DEVELOPMENT REVIEW BOARD
SUPPLEMENTAL SUBMITTAL

PROJECT NO. PR-2021-005687
Application No. SI-2021-00985

SUBMITTAL DESCRIPTION: Updated plan set, paving plan, memorandum addressing all comments from transportation

To: Ms. Jeanne Wolfenbarger, P.E., Development Review Board
From: Jim Strozier, FAICP
Date: April 22, 2022
Re: Response to PR-2021-005687 Transportation Comments

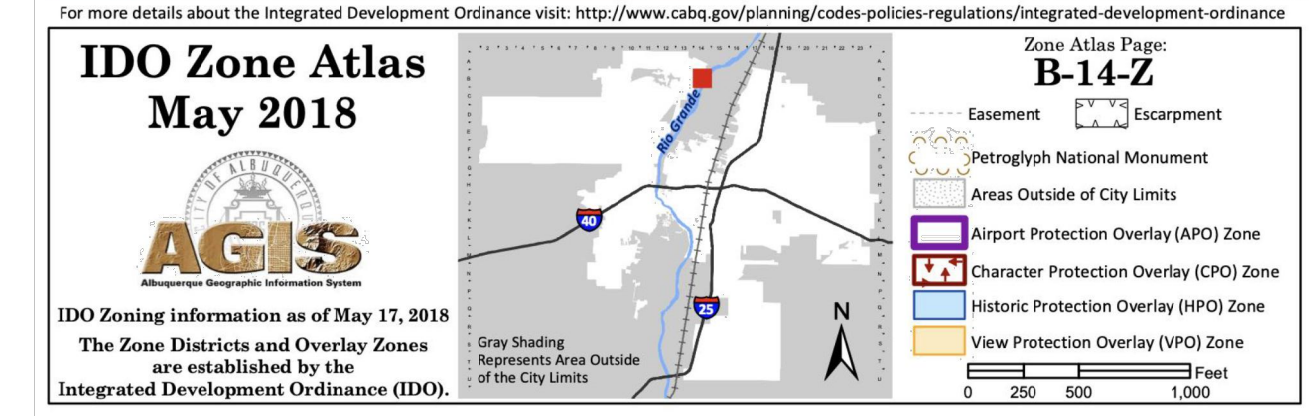
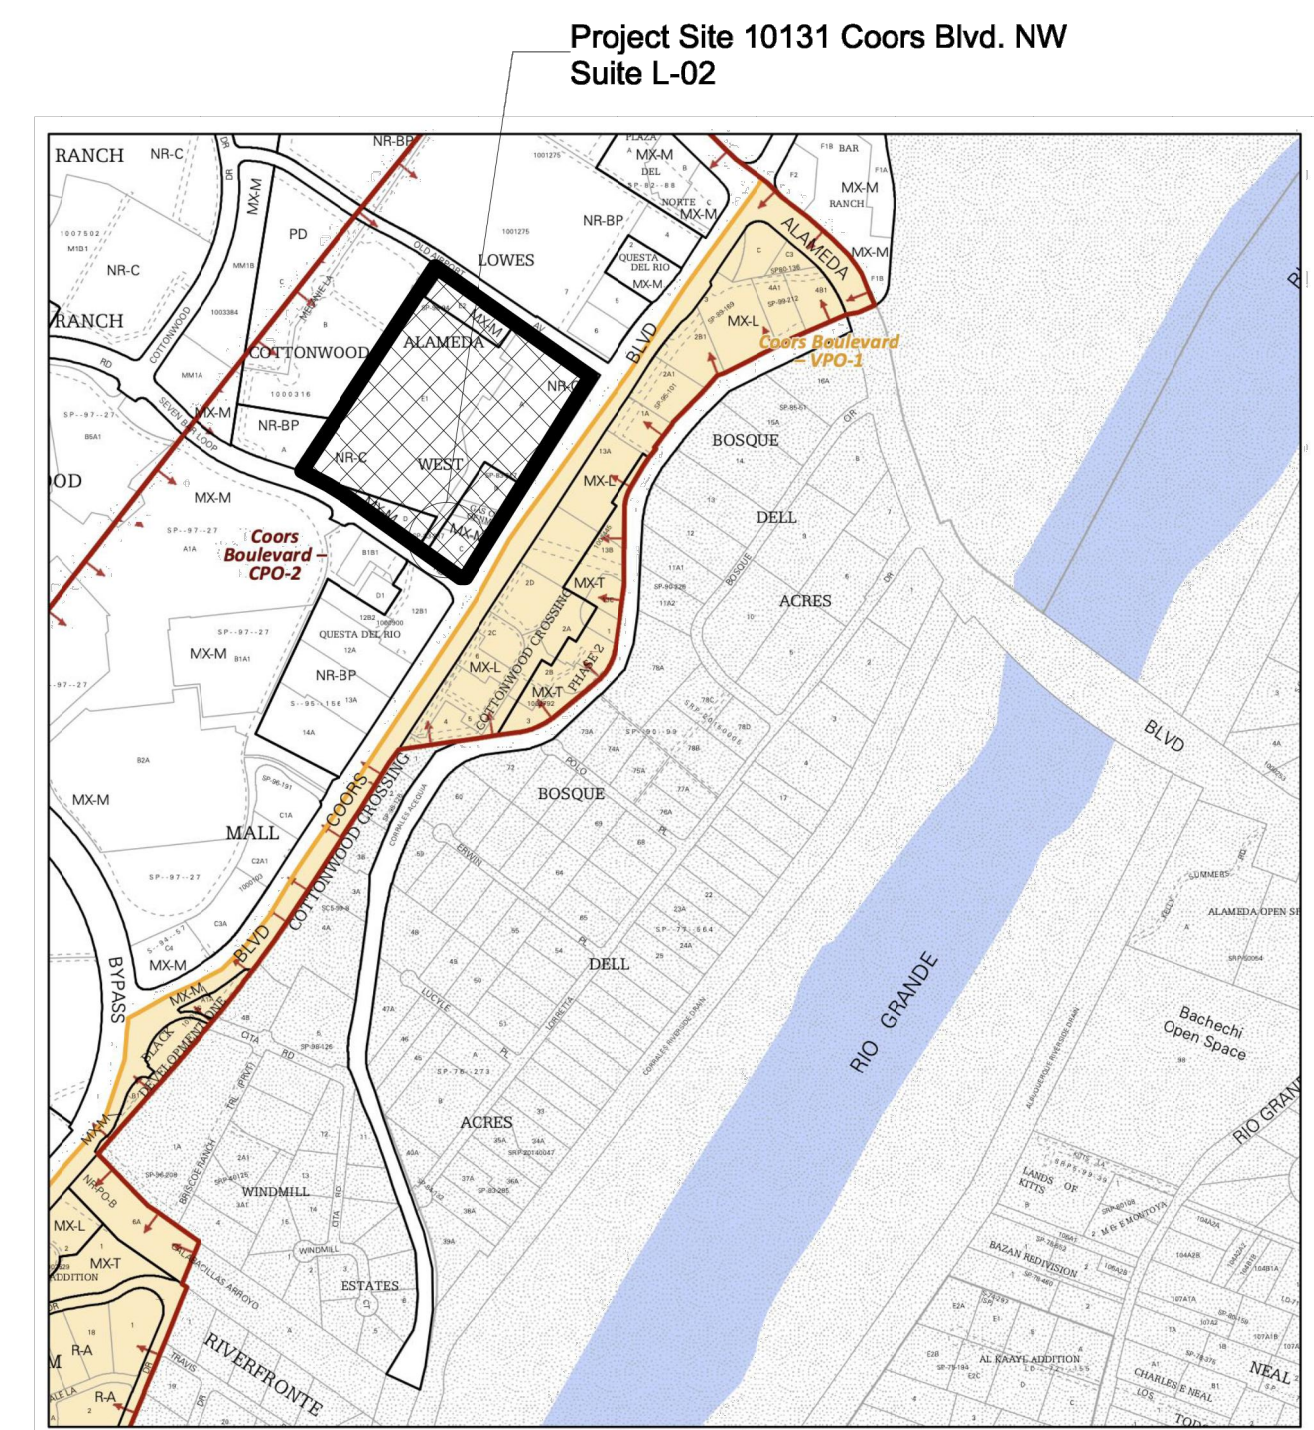
What does the 30-foot dimension represent on the plan view to the north of the site? (Any easements should be shown clearly.)

If the sidewalk is going to deviate from its typical path within the right-of-way, include a sidewalk easement and wayfinding signage, and label sidewalk connection at the west end. For sidewalk within Coors Boulevard, coordinate with NMDOT and include a note that it shall be built per a permit. If curb is going to be proposed on the infrastructure list, provide a cross-section for both COA review and NMDOT review and call out general location on the site plan.

Clearly show islands/channelization within the access to 7-Bar Loop along with proposed/existing lane widths. For any proposed work, include on infrastructure list.

Include all dimensioning for width of parking spaces for the compact spaces, handicapped spaces, and standard spaces. Follow minimum DPM requirements.

Label curb, parking bumpers, and paved parking spaces with keyed notes. List all curb radii, following the DPM requirements.

Use intersection clear sight distance for the access off of 7-bar Loop. Place this clear sight distance triangle on both the site pan and the landscaping plan.

RESPONSE: The 30 foot dimension is the width of the private access from 7 Bar Loop. We have added the note "Access Agreement per Declaration of Restrictions and Grant Easements dated 08/25/1983."

RESPONSE: The west end of the sidewalk has been labeled on site plan. A note for the sidewalk within Coors Blvd has been added that reads "Public 6' Sidewalk and Right-Turn Lane Extension to be Constructed by NMDOT Permit. Coordinate with Civil Sheets."

RESPONSE: Islands and channelization are now displayed on the site plan. Removal of existing median and additional striping is noted as private on site plan. Since these are improvements within a private easement, our understanding is that they should not be included on the infrastructure list.

RESPONSE: Dimensions for all parking spaces have been added to the site plan, in accordance with DPM requirements.

RESPONSE: Keyed notes have been added to the site plan which call out curbs, parking bumpers and paved parking spaces. A paving plan has been included as an exhibit with the supplemental submittal. All curb radii have been shown on the site plan in accordance with DPM requirements.

RESPONSE: An intersection clear site distance triangle has been placed on both the site plan and the landscape plan for the 7-Bar/private drive intersection.

PAINTED CROSSWALK AND ACCESSIBLE RAMPS

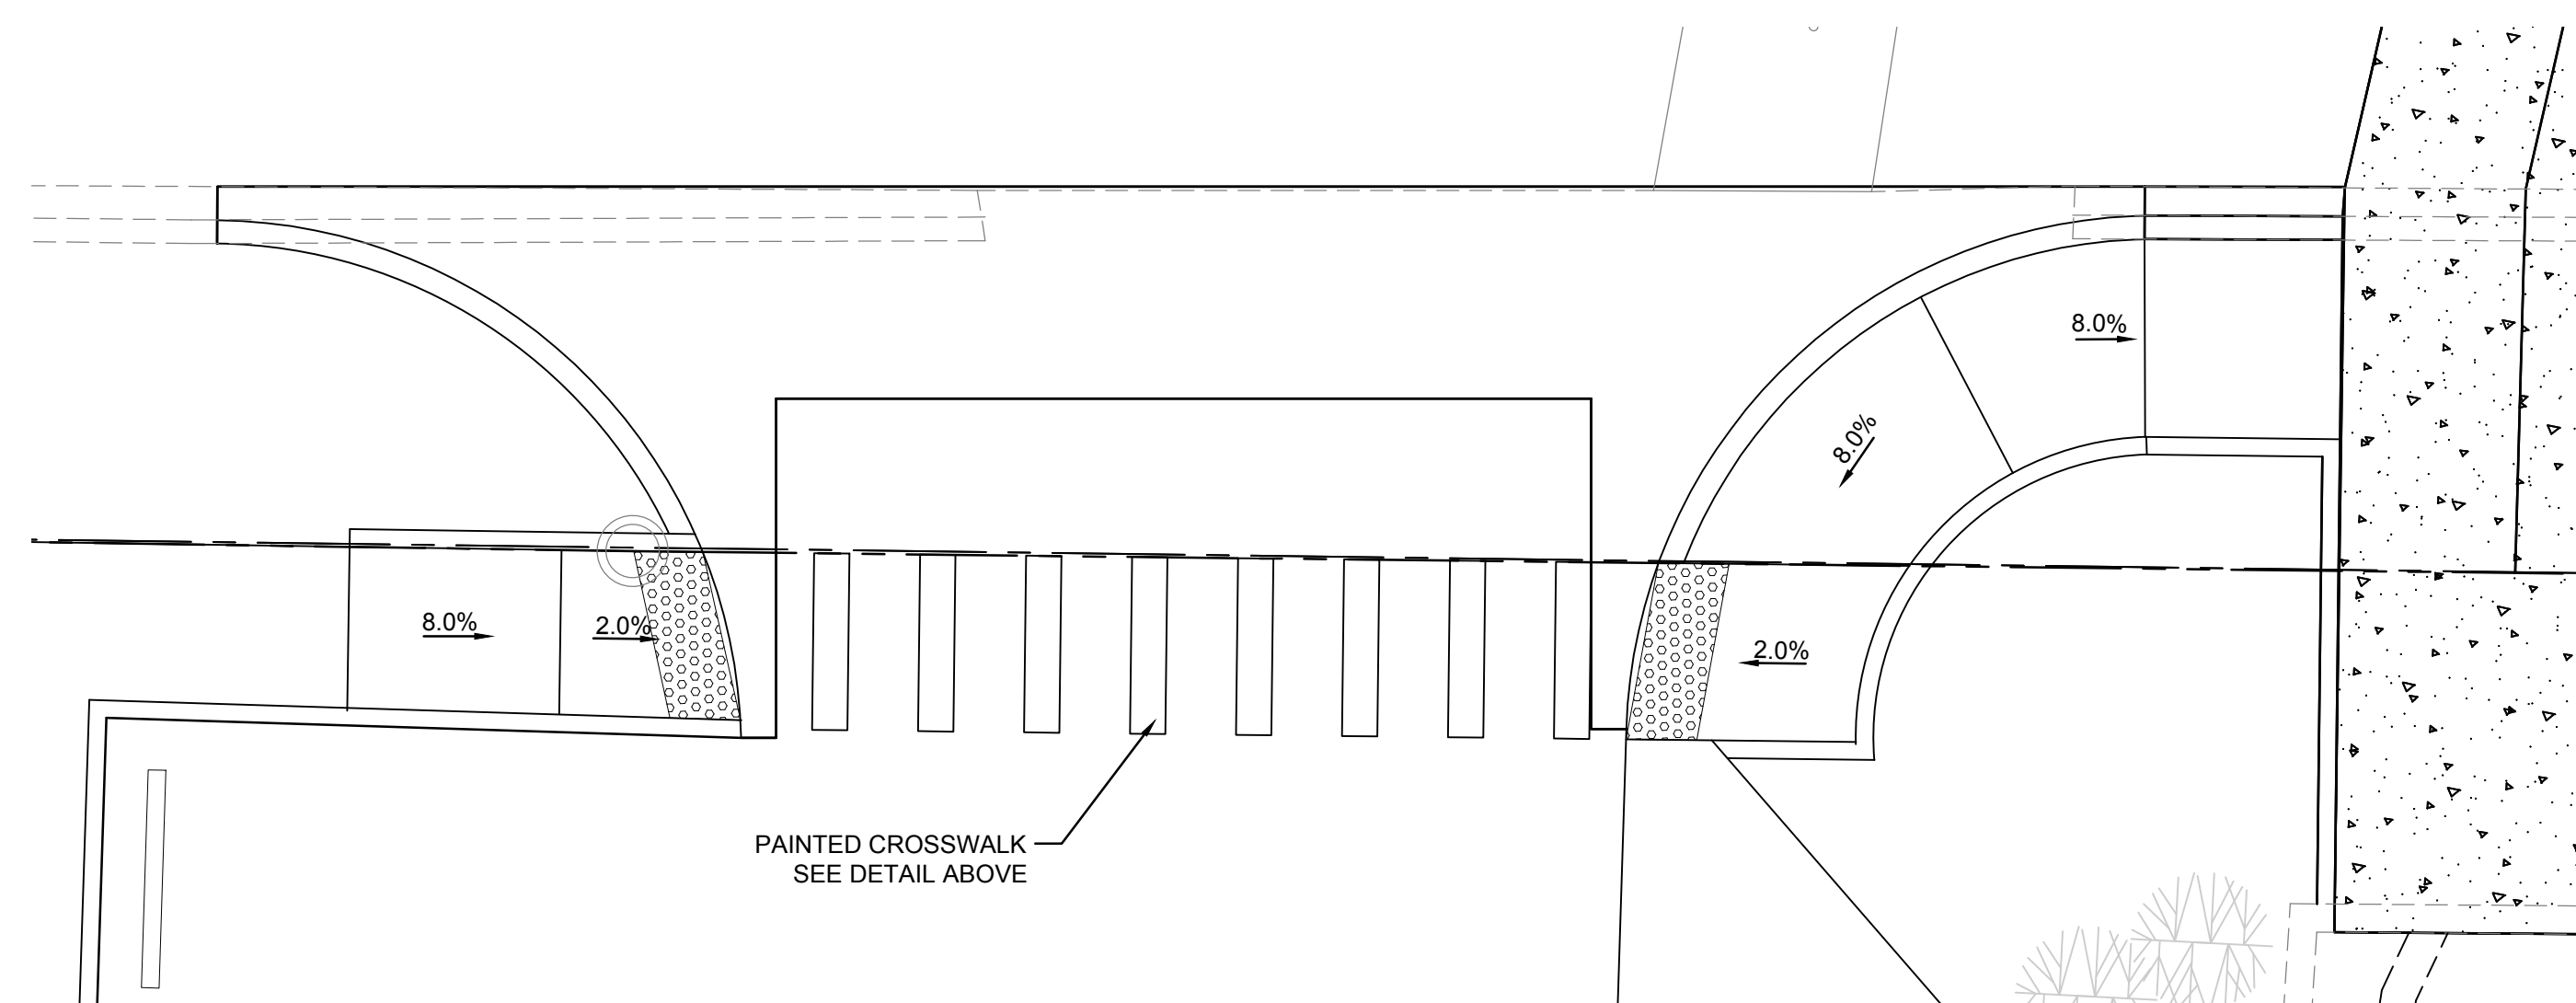
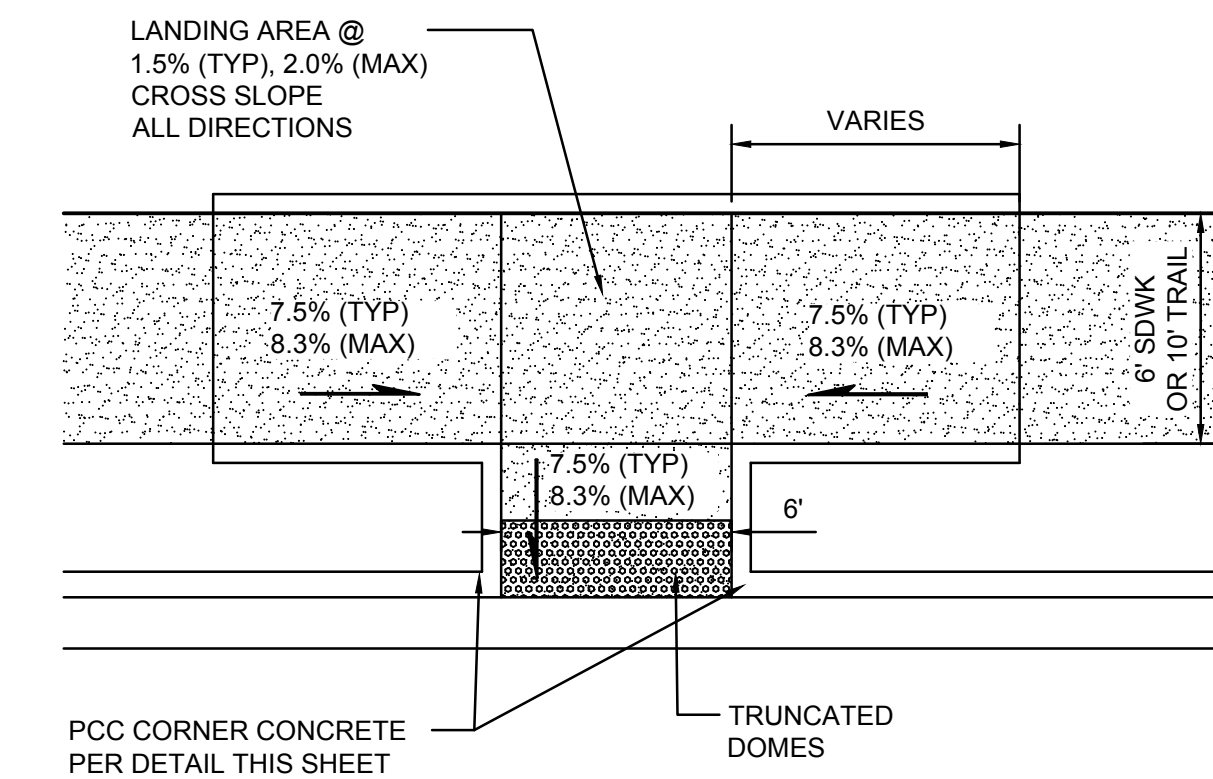
Designate all curb ramps on the site plan with a keyed note and include ramp details on the civil sheet along with the detail of the crosswalk.

RESPONSE: A keyed note has been added for all curb ramps on site, the details for which have been added to civil detail sheet.
